Beacon Hill Civic Association Architecture Committee Comments for June 2022 BHAC Hearing

Reviewed by BHCA Architecture Committee at its monthly meeting on Tuesday, June 14, 2022.

Below - Full inventory of entryways of all other north slope tenement buildings designed by notable Jewish Architect Max M. Kalman who was the architect for 44 Phillips St in 1919 (as well as the Vilna Shul, dated to 1919).

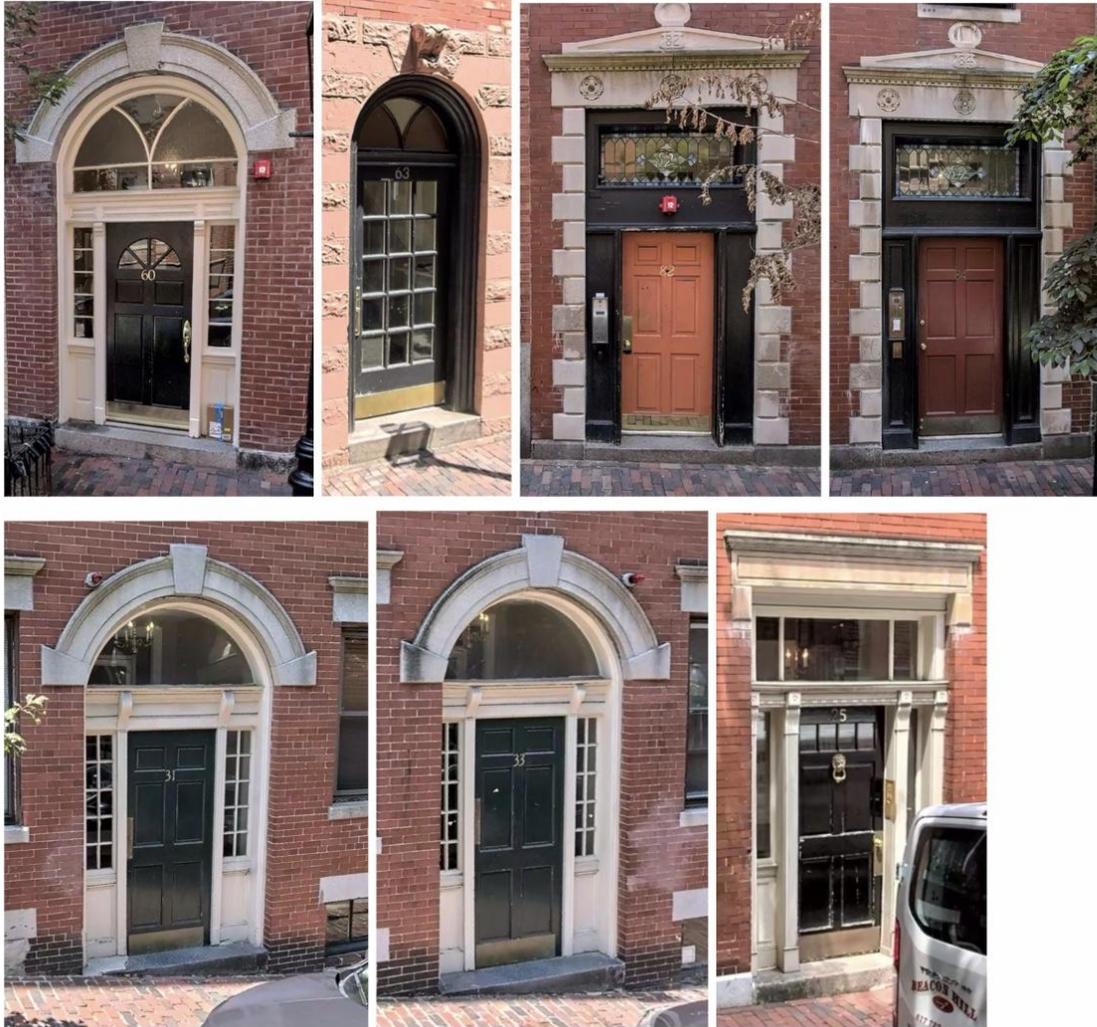
We were able to find a 1942 Permit stating that front double doors were removed and replaced with a single door with sidelites. We ask that the Applicant review other double-door entryway variations near this property and modify the application to replicate one of those or to pull together different elements to build a unique creation. Unfortunately, the few existing buildings known to have been designed by Max Kalman currently have single front doors. It would have been preferable to model an entryway after one of

his known designs. It does not appear that this entryway originated as one single door with colonial revival-style sidelites, even though this would have been more fitting for a building constructed in 1919. We have provided images and addresses of buildings known to have been designed by Kalman. We have also provided photos of other nearby entryways not designed by Kalman. Please see these attachments at the end of this document.
